HARRISCOMMUNICATIONS AND
INFORMATION HANDLING

SERVICE BULLETIN

MW-5/5A

AM-121-LAP
ECN-23815
July 19, 1978

RF Driver

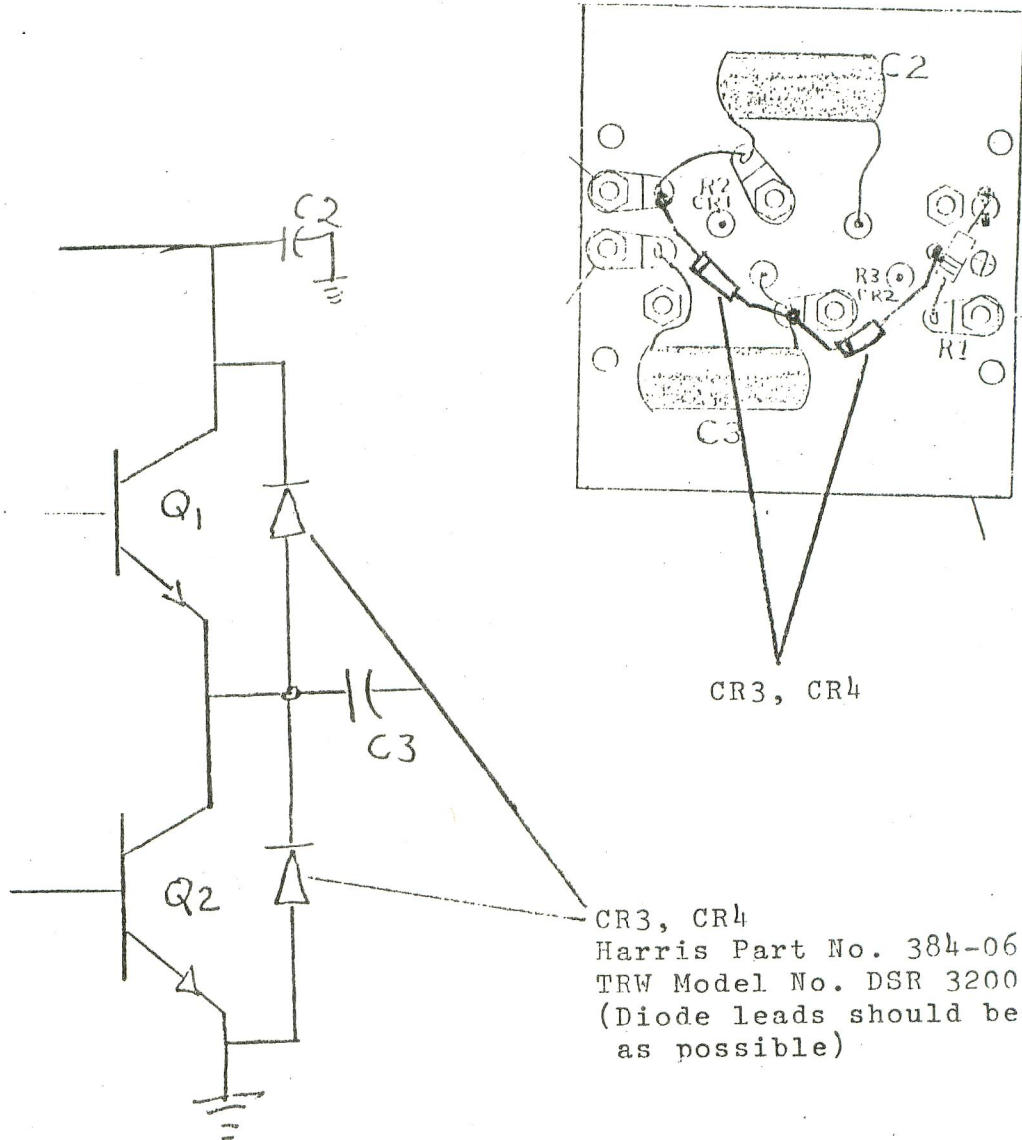
Problems encountered: Very sharp PA grid tuning; ringing of class 'D' waveform; random loss of RF driver transistors Q1 & Q2 in through A5 in IPA RF driver 1A2A3A1 (992-3820-001) assemblies.

The major supplier of these 2N6340 transistors (Motorola) have changed the doping mixture used to manufacture the collector emitter junction's structure. Thus, the newly created junction characteristics cause the operational duty cycle to be unstable.

CR-3 and CR-4 (25 nanoseconds reverse recovery time clamping diodes) have been added across the emitter to collector of Q1 & Q2; 1A2A3 A1 through A5.

Q2, Q1 lable should be reversed

Connect diodes between existing solder lugs, as shown in the attached drawing, on the back of each RF driver assembly. Cut both diode leads as short as possible and approximately the same length. Ground the anode of CR-4 to heat sink solder lug. Dress leads carefully, making sure they don't come in direct contact with other components. Be sure to heat sink carefully the diode leads when soldering.

CR3, CR4
Harris Part No. 384-0678-000
TRW Model No. DSR 3200
(Diode leads should be short
as possible)
